SCOPE CHANGE / QUESTION & ANSWER

Request for Proposals - Department of Housing and Community Development Maryland Broadband Infrastructure Grant Program

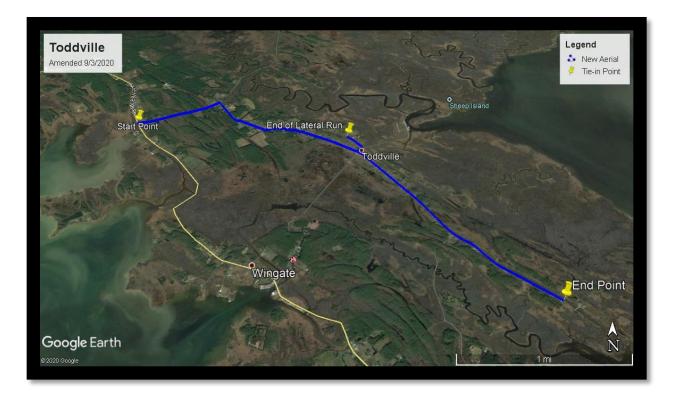
Question #75: From the SMECO substation to Trinity Church Rd, would a second 2" conduit be a good idea?

Question #76: From Ryceville Rd, South to Rt 234, would a second 2" conduit be a good idea?

Answer #75: (1) 2" conduit for this Scope of Work.

Answer # 76: (1) 2" conduit for this Scope of Work
